Notice of Decision

Middle Housing Land Division (Tentative Partition Plat)

PA-04-24

Proposal:	Middle Housing Land Division to divide a 16,412 square foot parcel into four lots.
Review Body:	Staff (Review Type N/A)
Staff Report Prepared By:	Liz Olmstead, project planner
Property Owner/Applicant:	Scott Lepman; Glorietta Bay, LLC; 100 Ferry Street NW, Albany OR 97321
Address/Location:	1955 Water Avenue NE
Map/Tax Lot:	Linn County Assessor: 11S-03W-05CA Tax Lot 10600
Zoning:	RS-5 (Residential Single-Dwelling Unit)

Sheet **C1.1**
 SCALE: SEE BARSCALE

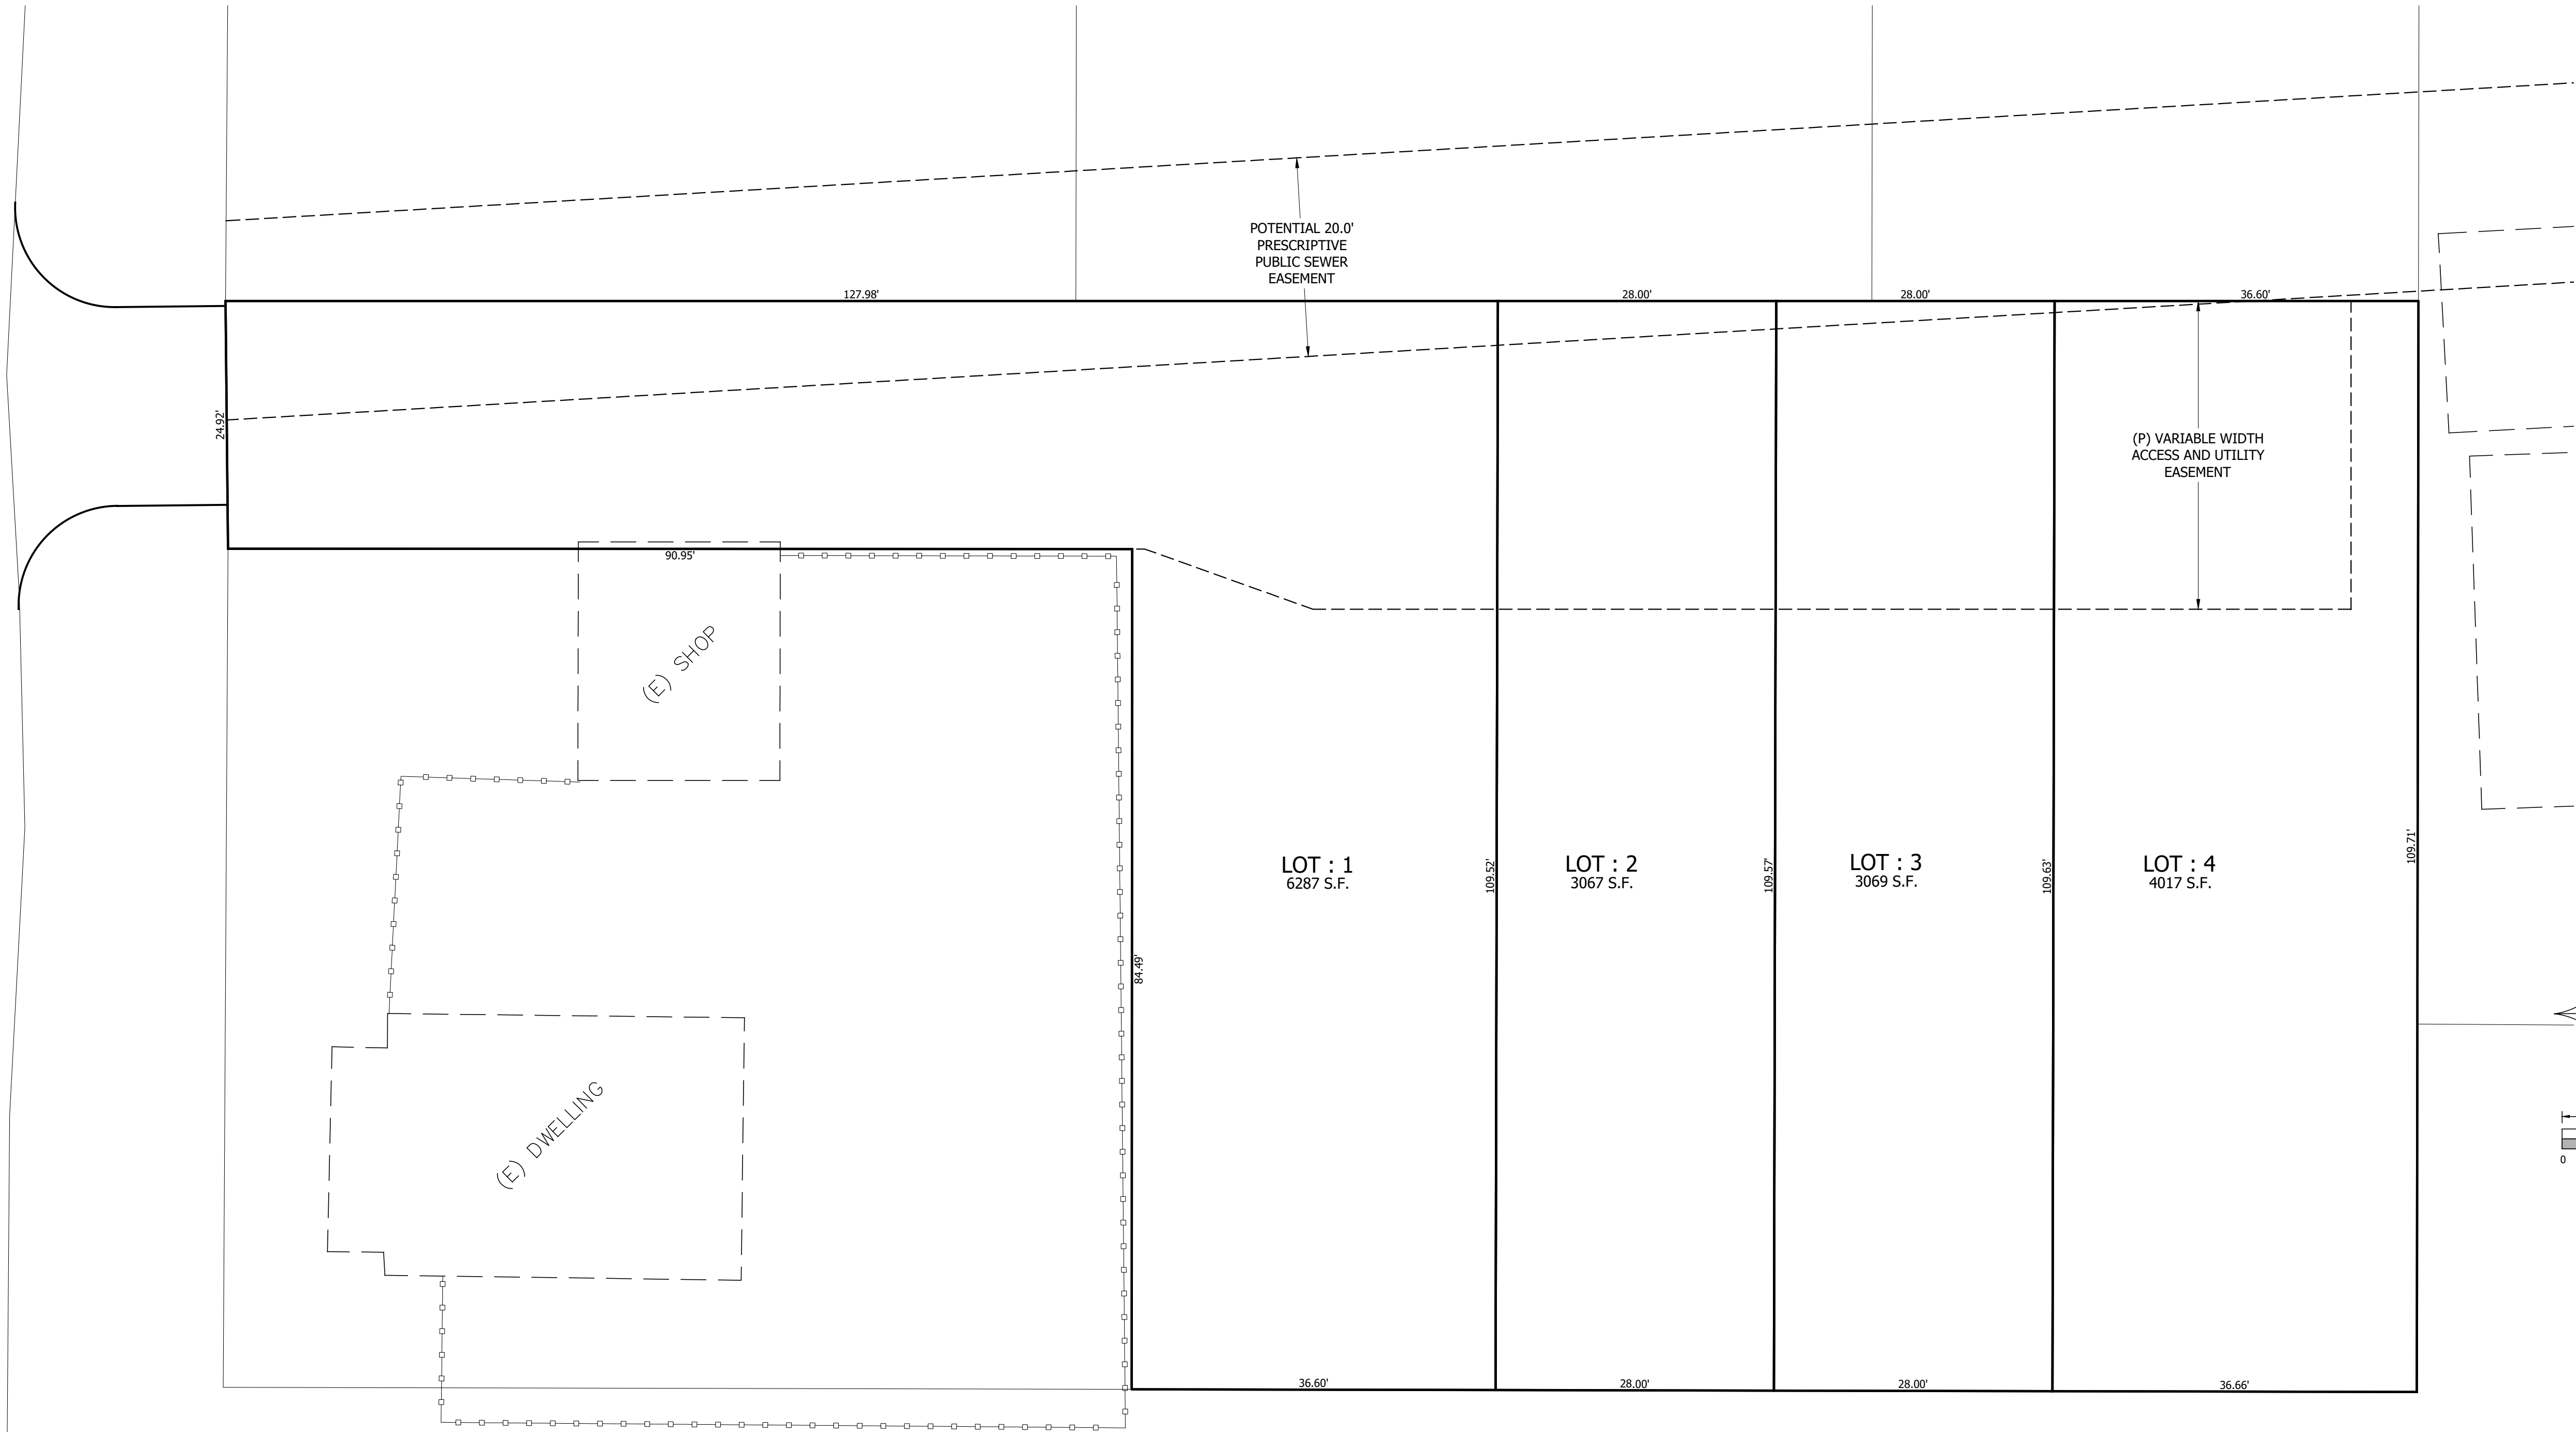
- Condition 5** Prior to recording the final plat, a 36-inch-wide emergency access easement benefiting lots 2 and 3 shall be provided on the adjacent lot(s) to provide emergency egress for sleeping rooms to comply with the Oregon Residential Specialty Code.

A hydrant will be required due to distance to the structure. The one proposed is acceptable.

Sheet **C1.2**
 SCALE: SEE BARSCALE

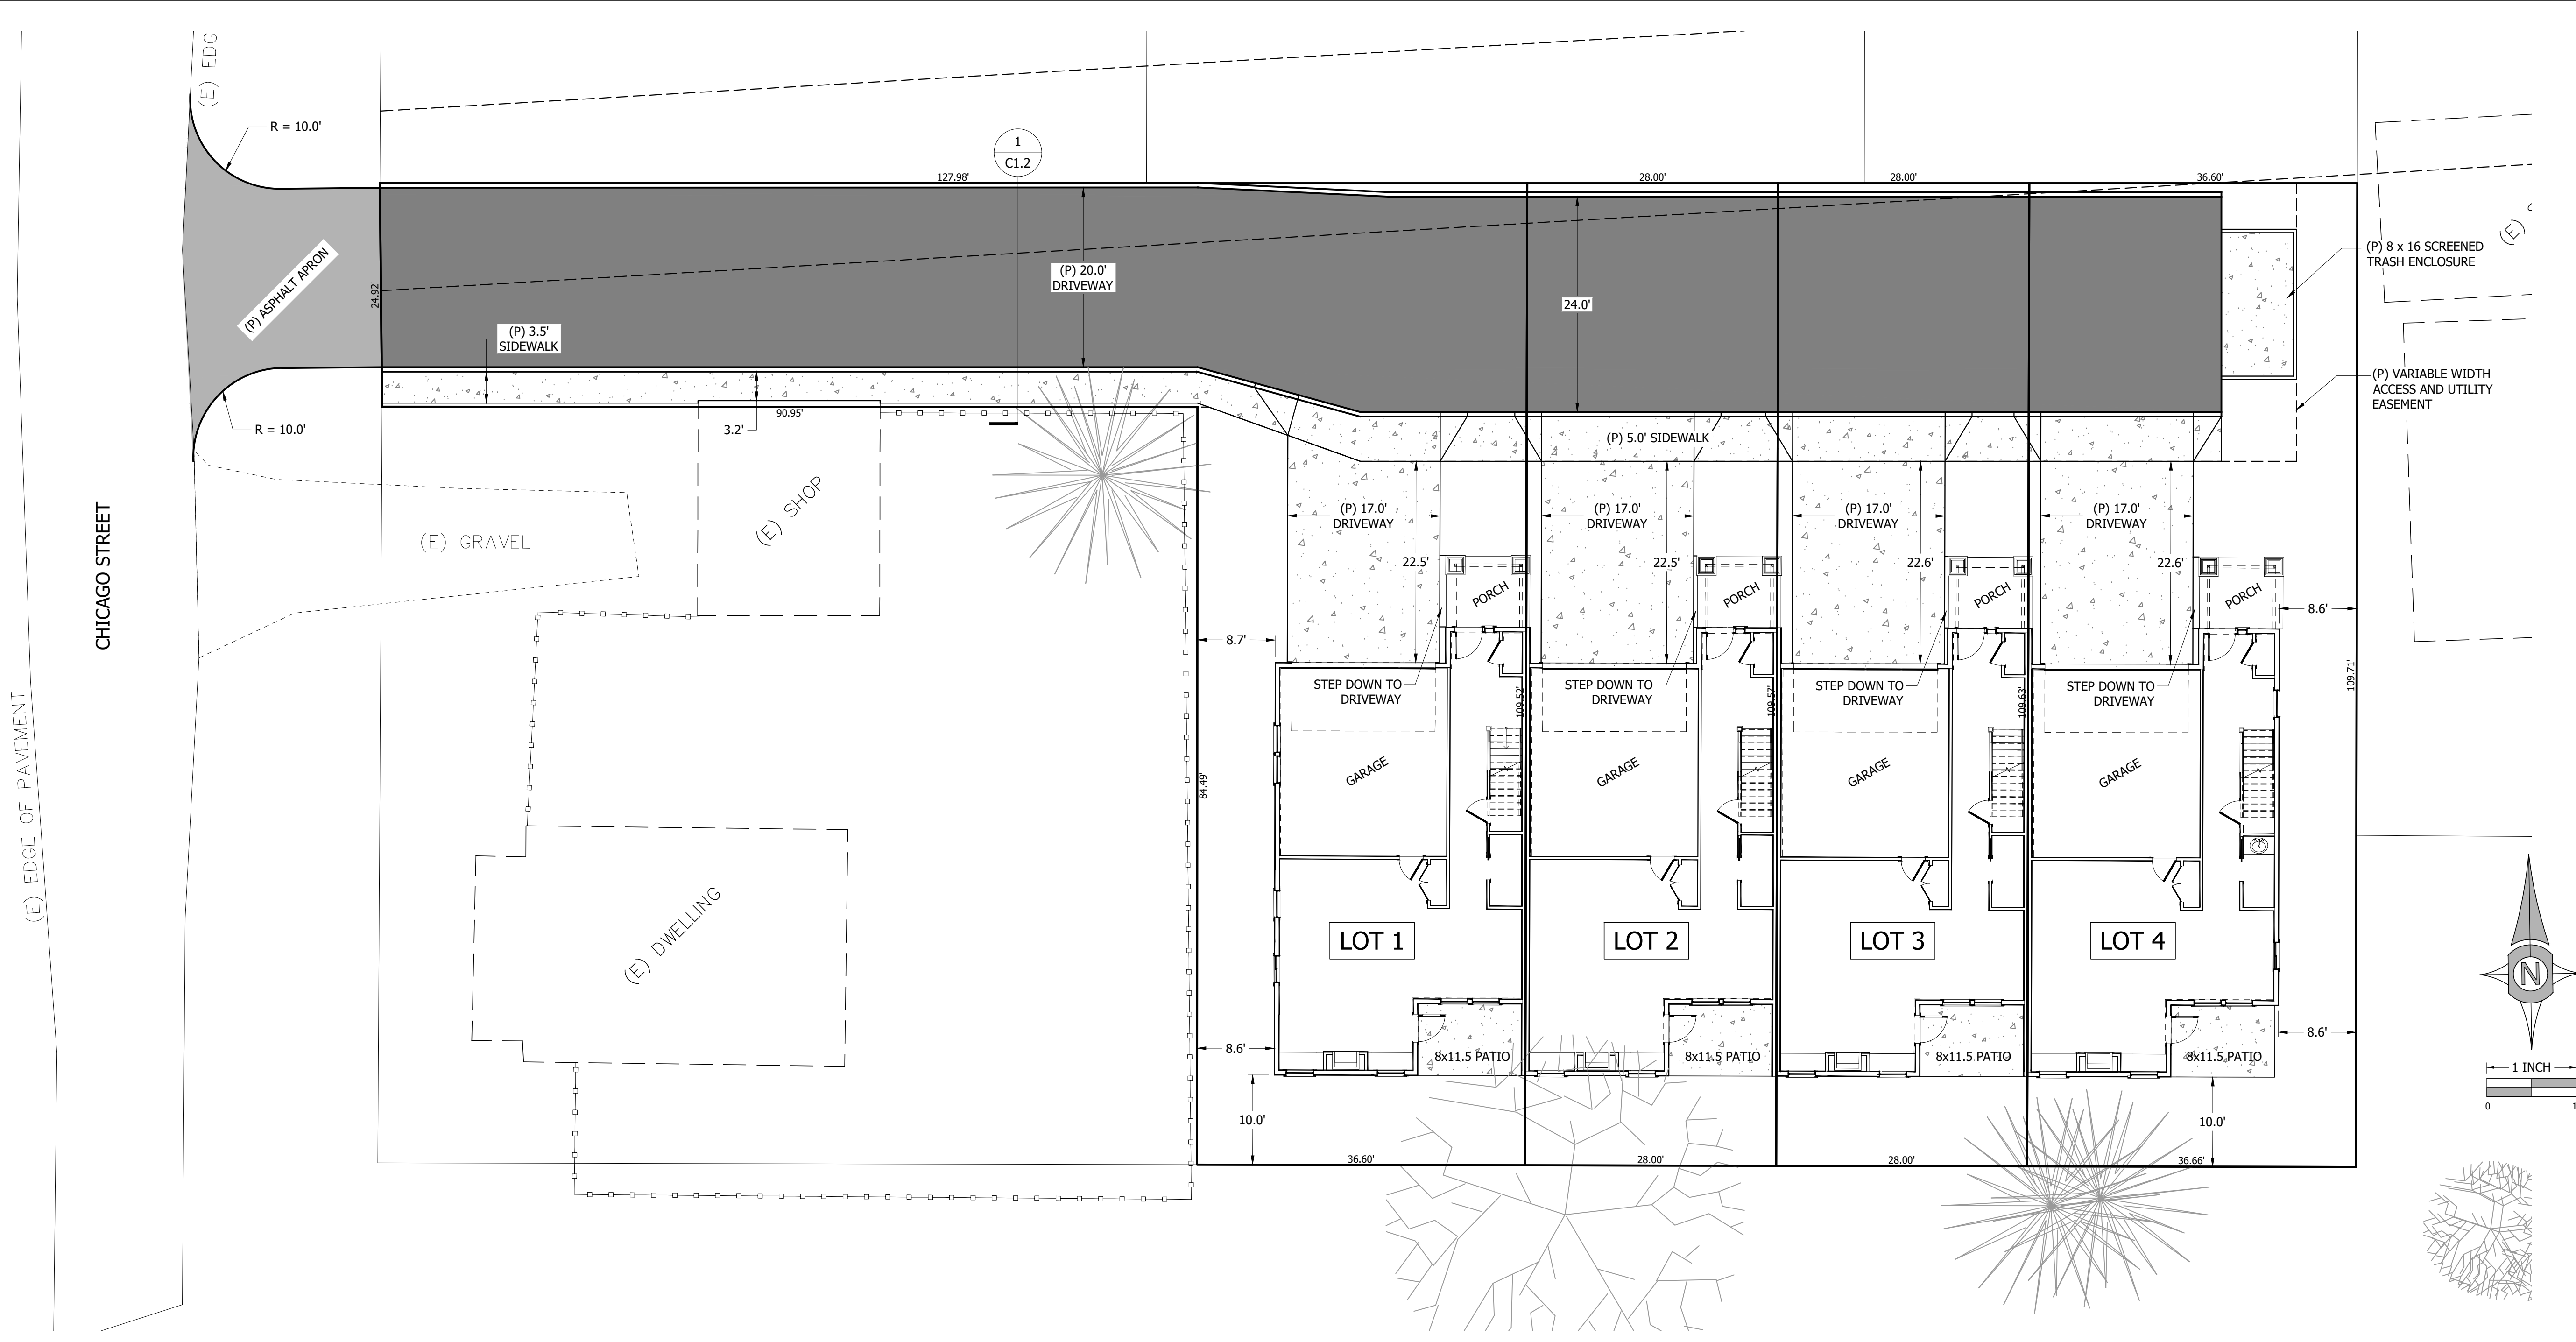
- Condition 1** Prior to approval of the final subdivision plat, the applicant must construct public storm drainage improvements from Front Avenue NE to the southern boundary line of the subject property in Chicago Street NE. In addition, the applicant must construct stormwater detention facilities that comply with the City's Engineering Standards.

- Condition 2** Prior to approval of the final subdivision plat, the applicant must dedicate the portion of the 20-foot public sanitary sewer easement located on the subject property to the City.

- Condition 3** Prior to approval of the final subdivision plat, the applicant must obtain a water meter permit for installation of water services to serve each lot of the subdivision.
